STAFF REPORT
WEST ALLIS PLAN COMMISSION
Wednesday, December 11, 2024
6:00 PM

4. Site, Landscaping, and Architectural Design Review for La Finca, a proposed Restaurant (limited), at 7033 W. National Ave. (Tax Key No. 453-0602-000).

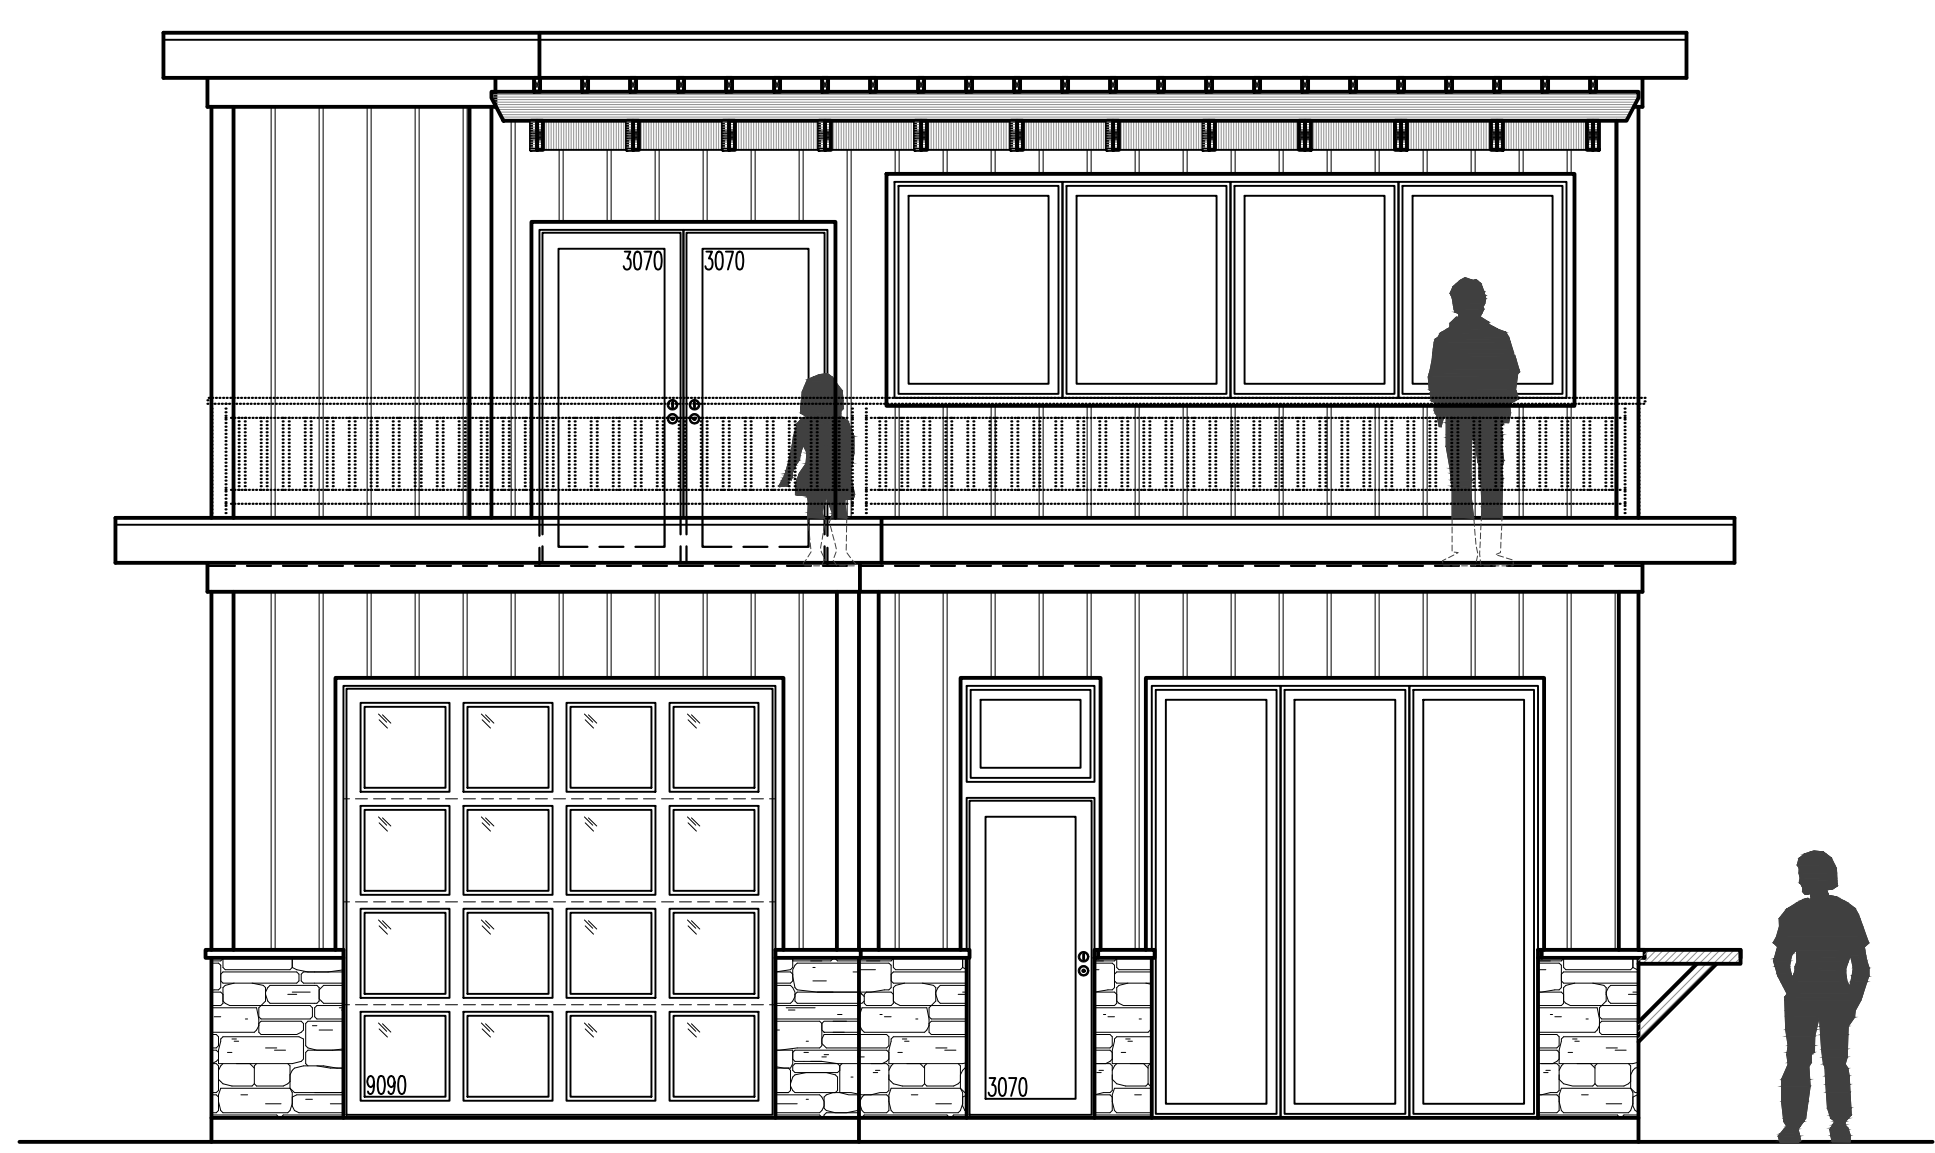
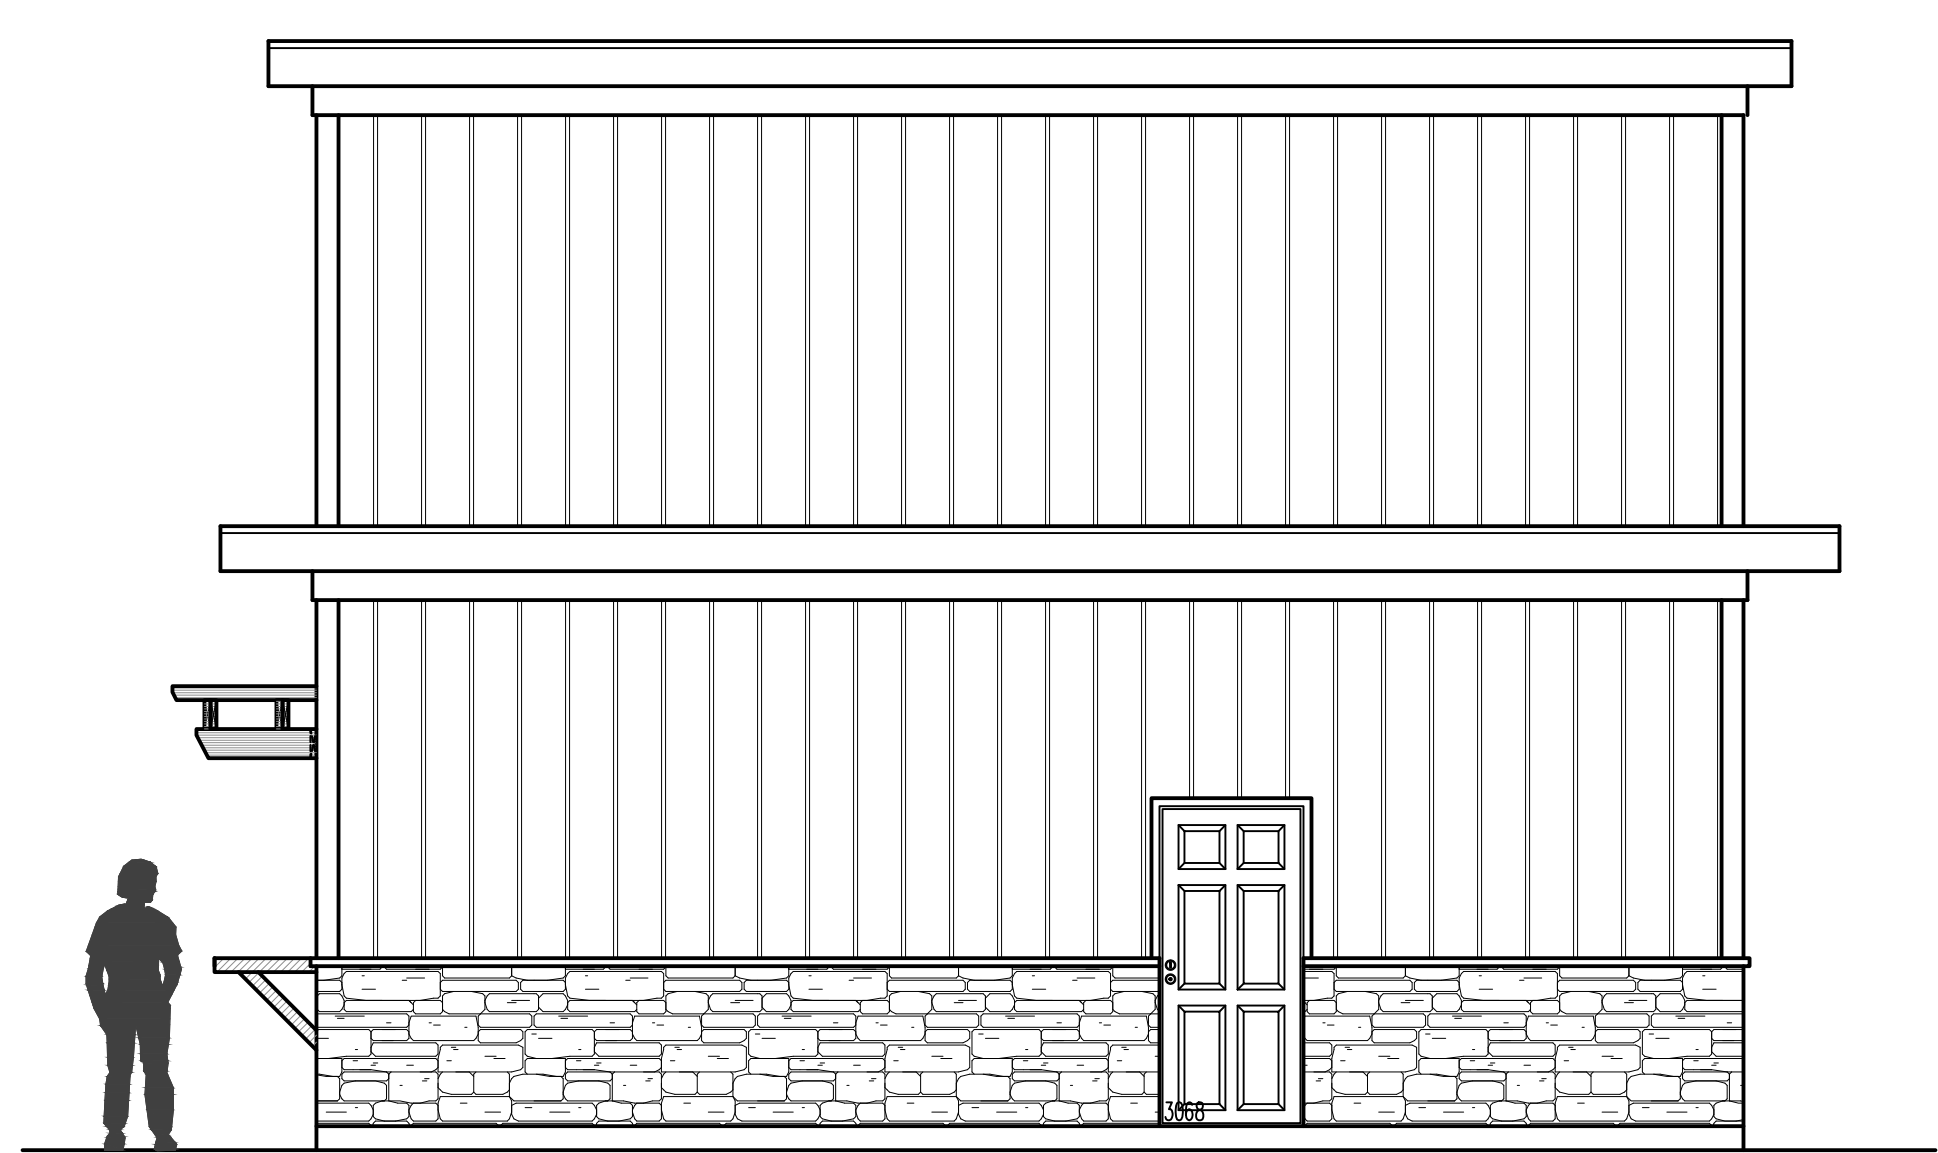
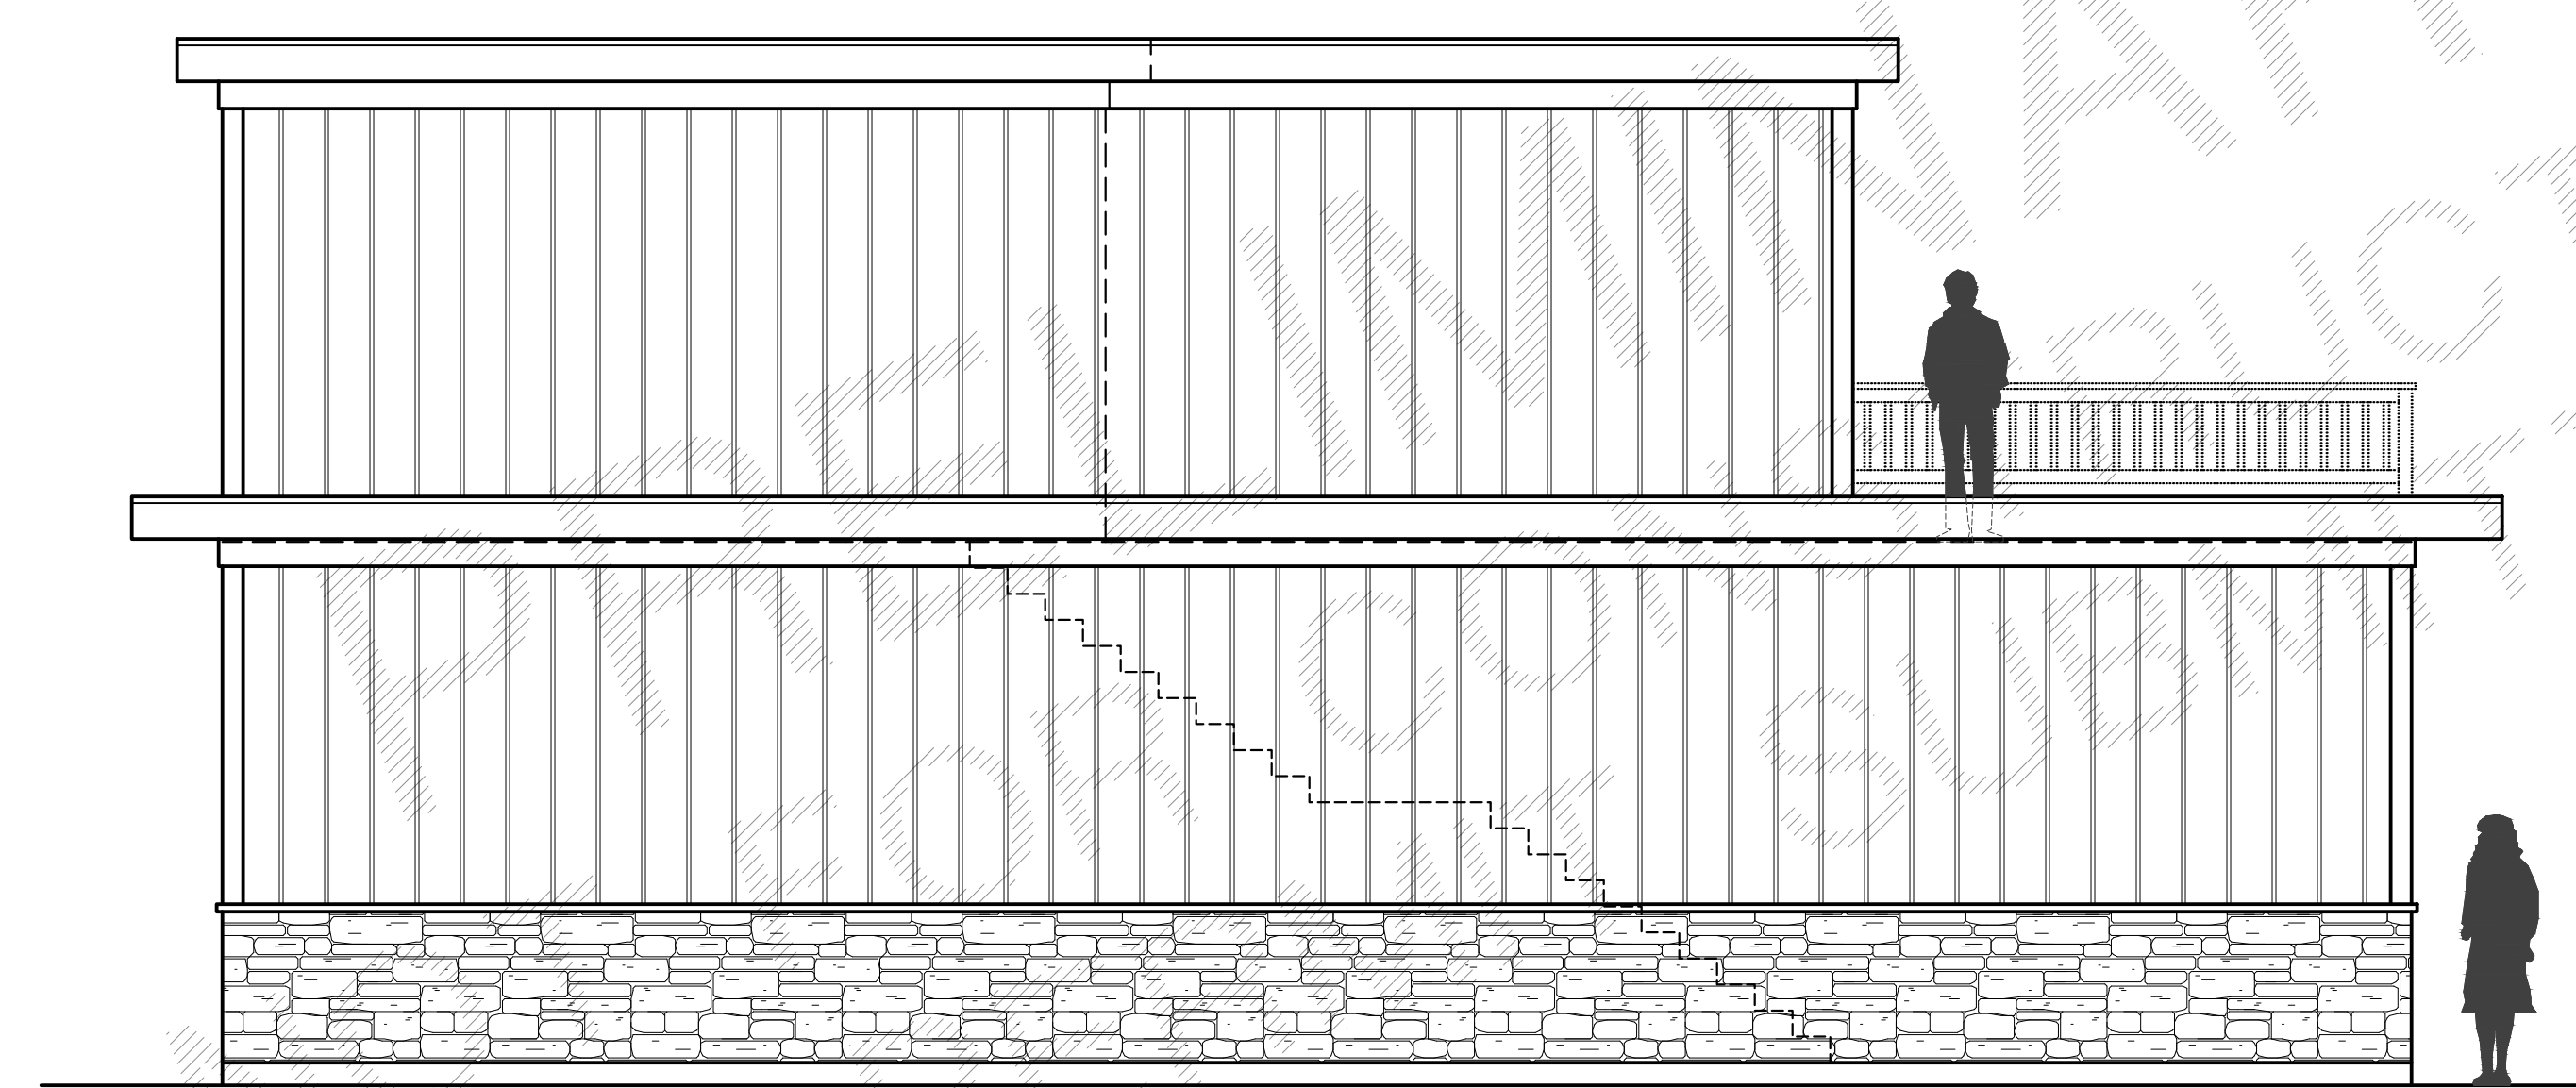
The architectural plan shows an overhaul to the exterior of the existing building. The proposed building features natural cut stone with ledgestone that wraps itself around the base of the entire building. Immediately above the stone is LP board and batten. As an alternative to the natural cut stone and LP siding proposal, the applicant has indicated that there may be an attractive brick underneath the existing metal siding. Staff has encouraged the applicant to remove areas of metal siding to explore what exists underneath, as this could potentially be an attractive option to the proposed.

The elevation along W. National Ave. shows a storefront with an aesthetically pleasing design. A glass door provides access to the building. Next to this door are three large commercial storefront windows. There is also a large overhead garage door, with glass panels, serving as an additional access point. The rooftop patio seating area is also prominently visible from this façade. The visible second floor features from the street will be the seating area, glass entrance door, store front windows, black rod iron railing, and decorative pergola. Moving to the west façade, this serves as another prominent entry point. Proposed is a glass entry door along with another overhead garage door with glass paneling. Directly next to the glass door is a pedestrian walk-up window where orders can be placed. This feature is complemented by a pergola. Additional storefront windows make their way throughout the first floor of the west façade. Visible on the second floor on the west façade are more windows. The south and east elevations feature less prominent architectural features due to their less visible locations. The south elevation features a door that will be used for the business for needs such as refuse collection.

and 4-sided screening details including consideration of locating refuse area south of alley, (d) the applicant apply for a Commercial On-Street Accessibility Parking Zone permit; (e) removal of test areas of existing metal panel siding to explore restoration of brick as an option of adding new siding; (f) landscaping amenities being located on site including planter boxes, wall-mounted planters, trellises, or other features to enhance streetscape and buffer adjacent properties (g) location of any lighting on the site.
